RE: Port Pheonix Water Way Marina – DCI2023-00054 – Major PD

Please find below responses and commentary to the provided comments from staff in your January 7th, 2025 letter regarding the Commercial Planned Development Application for Port Pheonix Water Way Marina (DCI2023-00054).

SHEET:
AT-1
1 OF 2

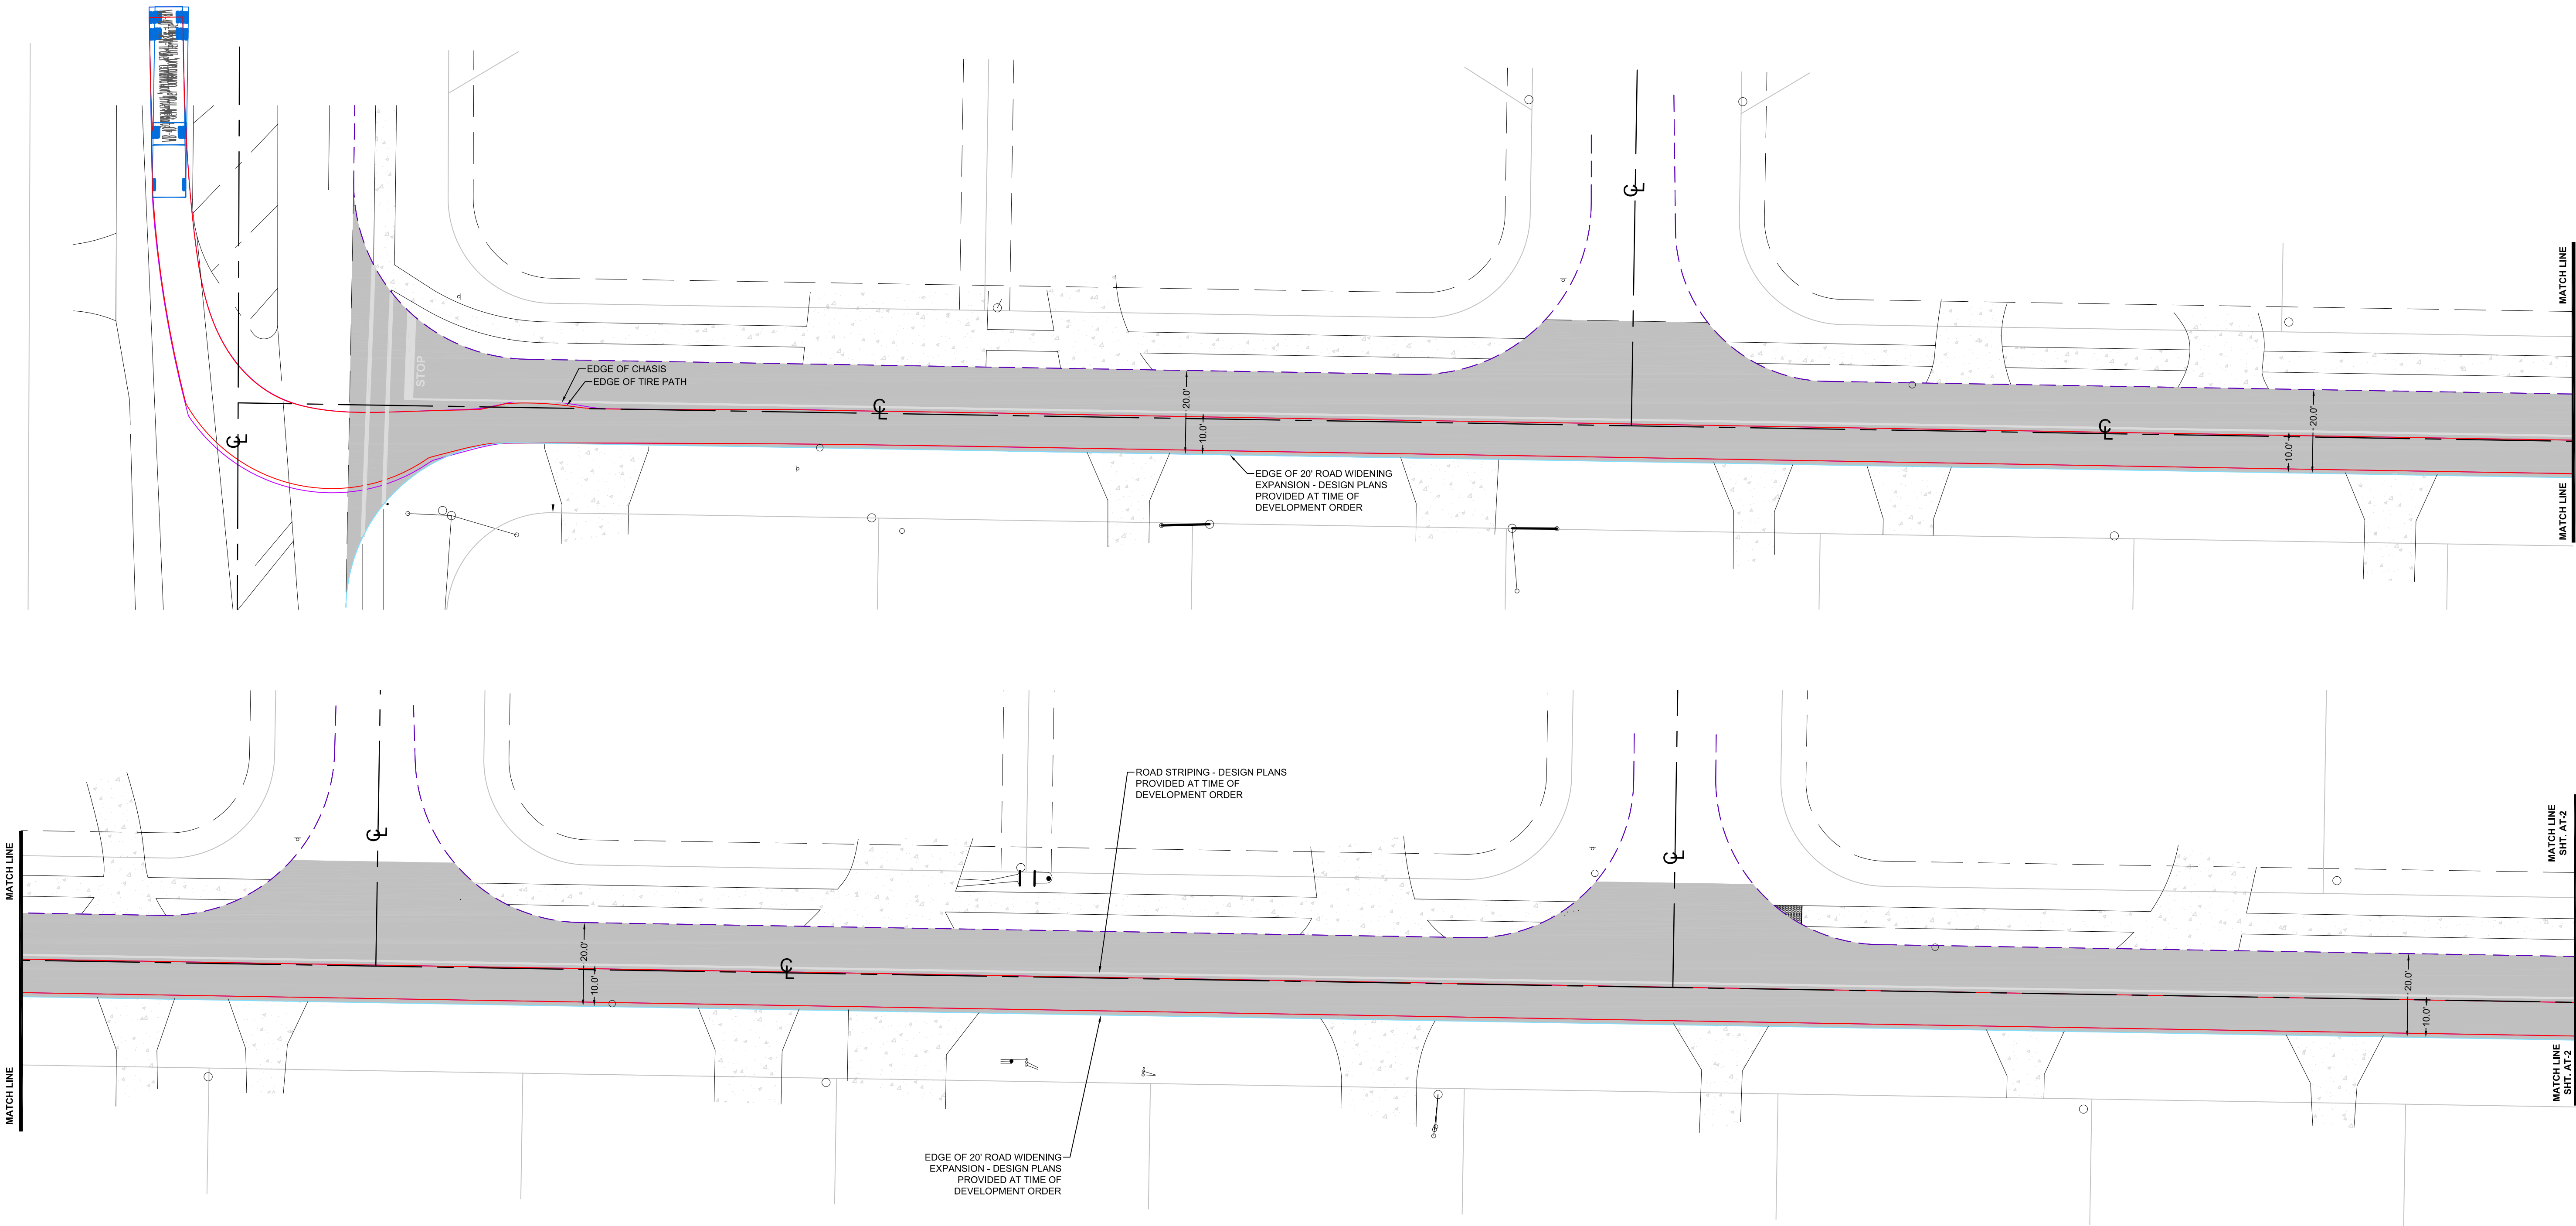
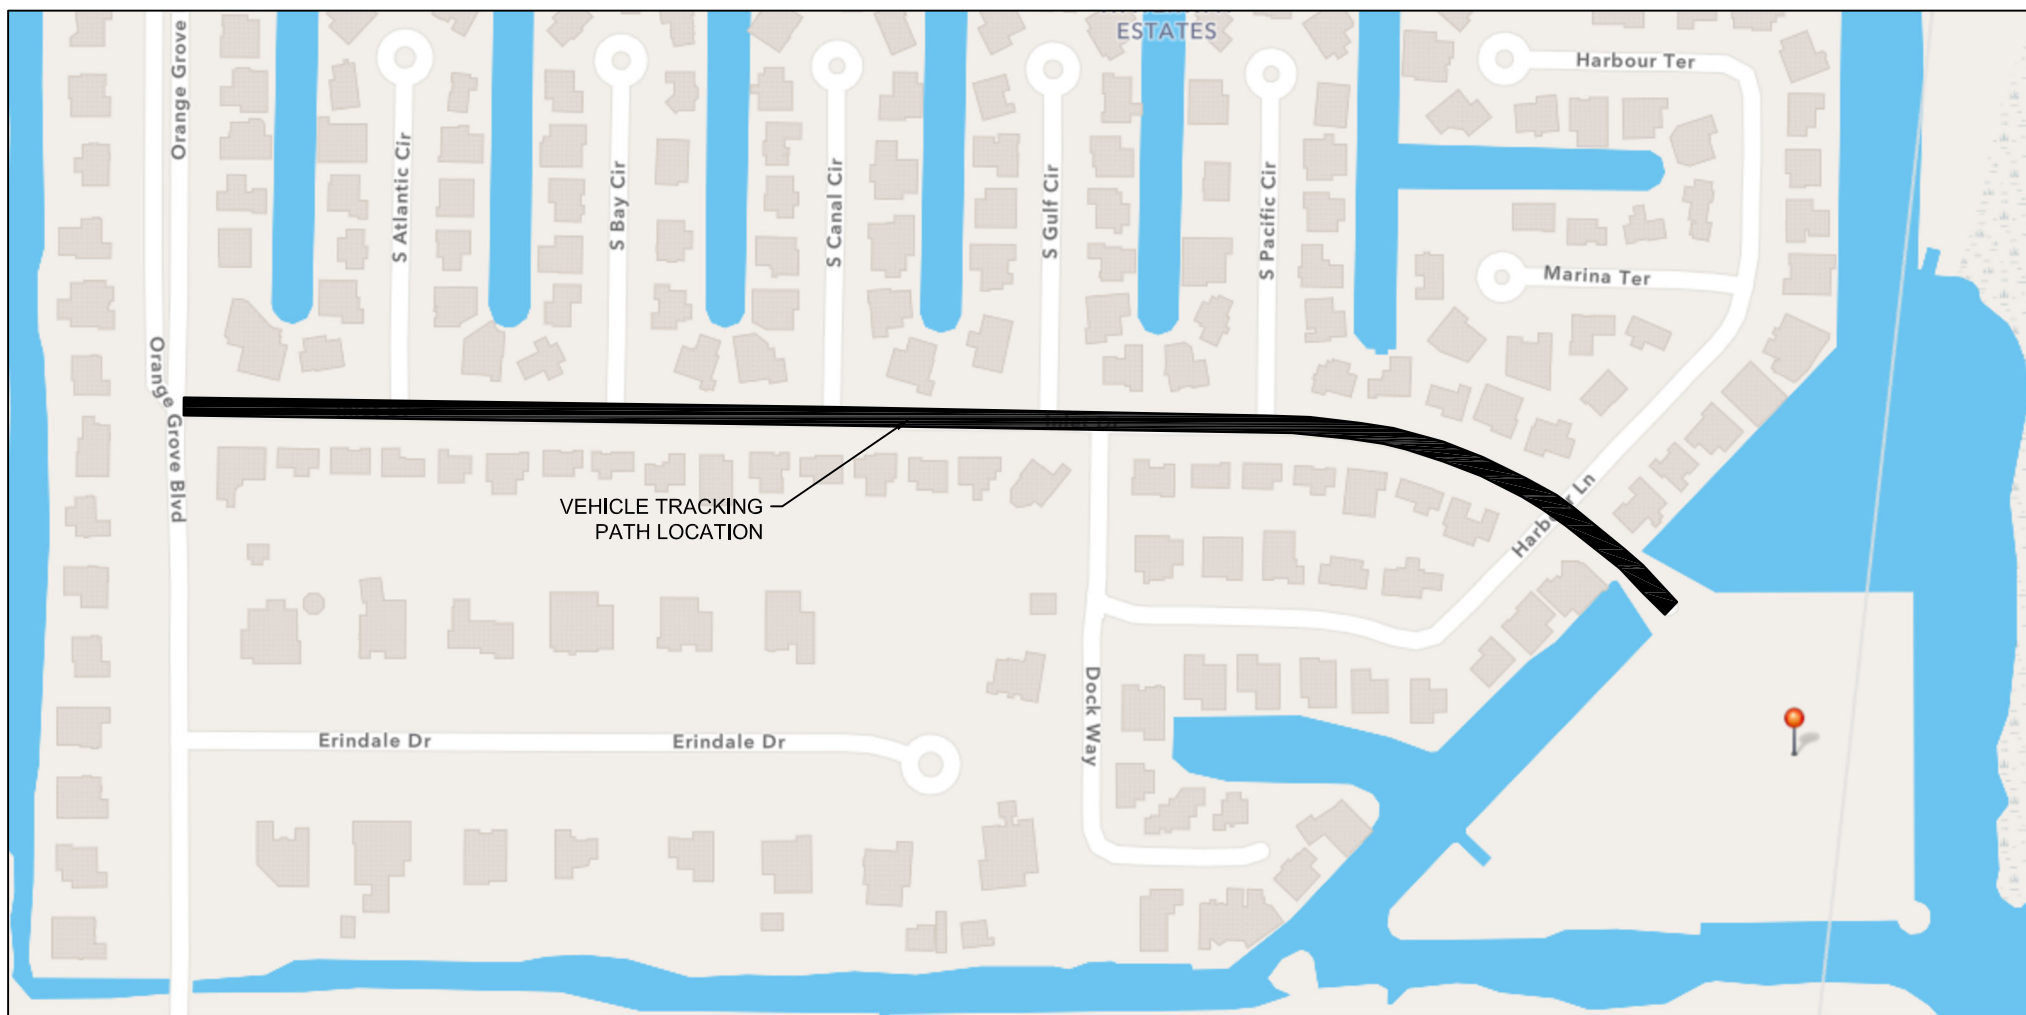
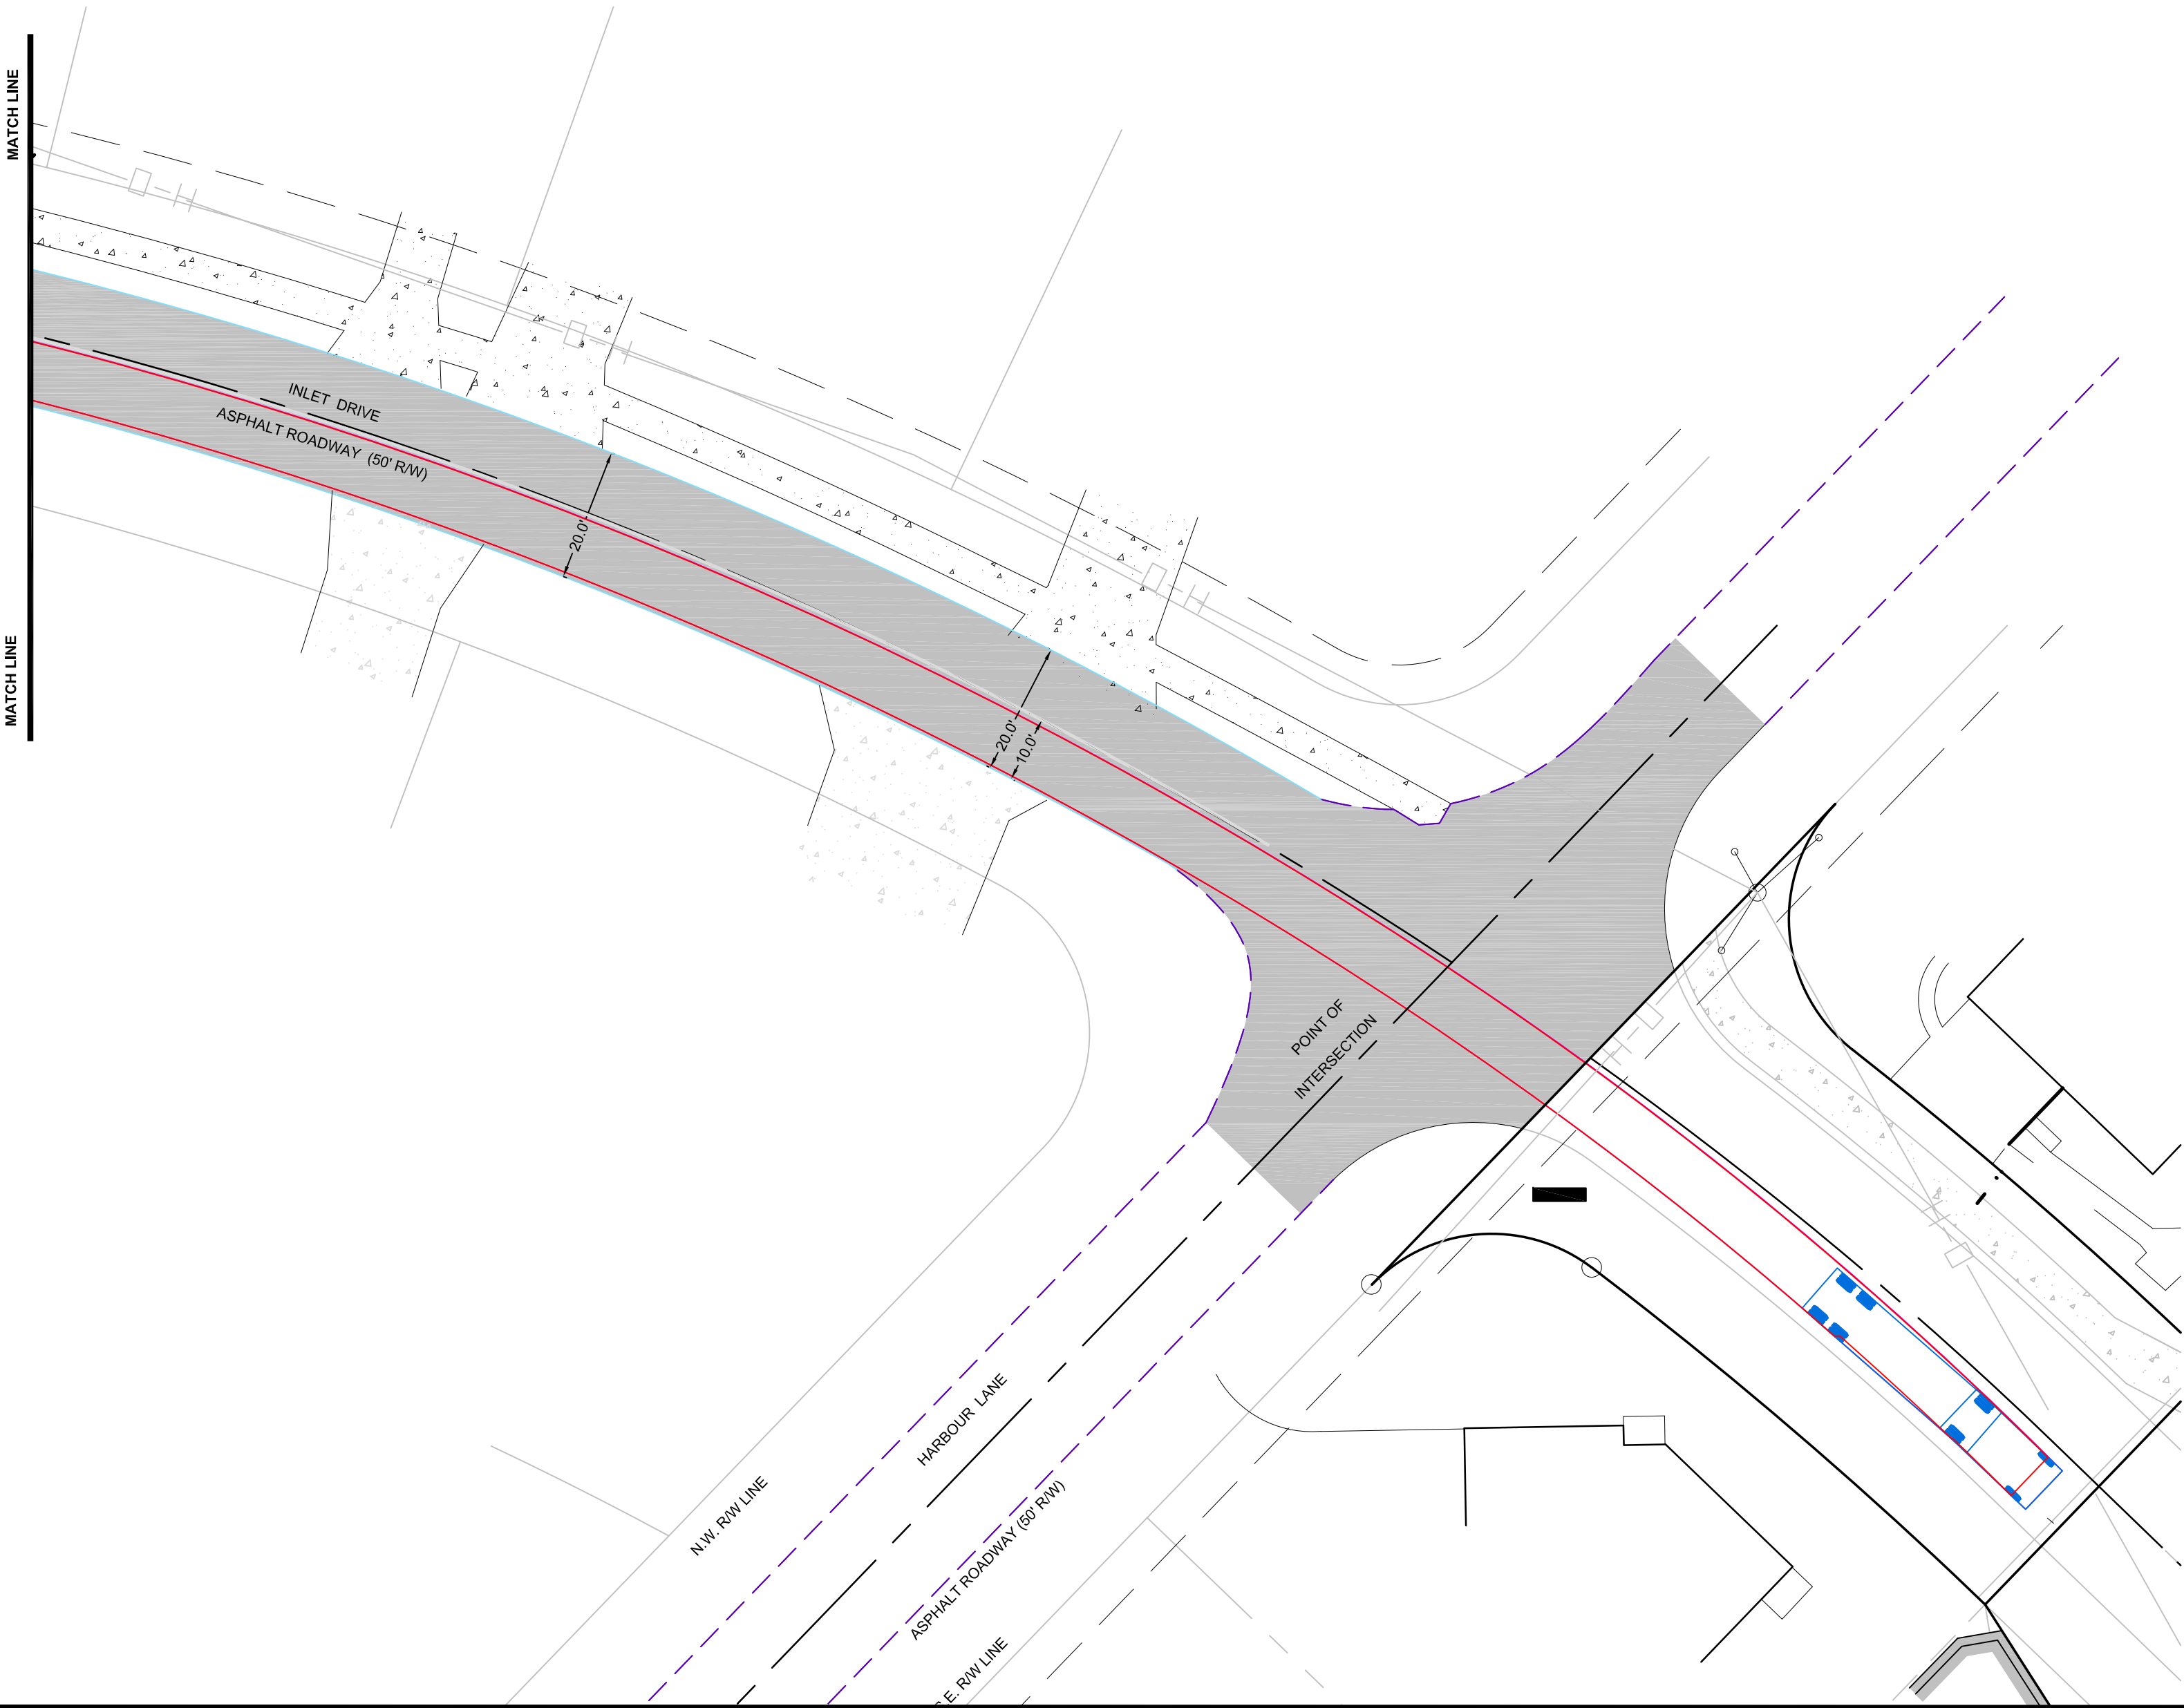
1. *Provide the Inlet Dr road widening exhibit showing information on the proposed asphalt road widening as specified in the WB-40 AutoTURN Exhibit.*

Per coordination with Brian Roberts, it is understood that this comment relates to a note regarding additional minor asphalt changes that were included in the auto-turn Exhibit. We have revised the conflicting note for clarity. Any required road modifications will be permitted at the time of Development Order submittal. Please refer to the updated Auto turn Exhibit.
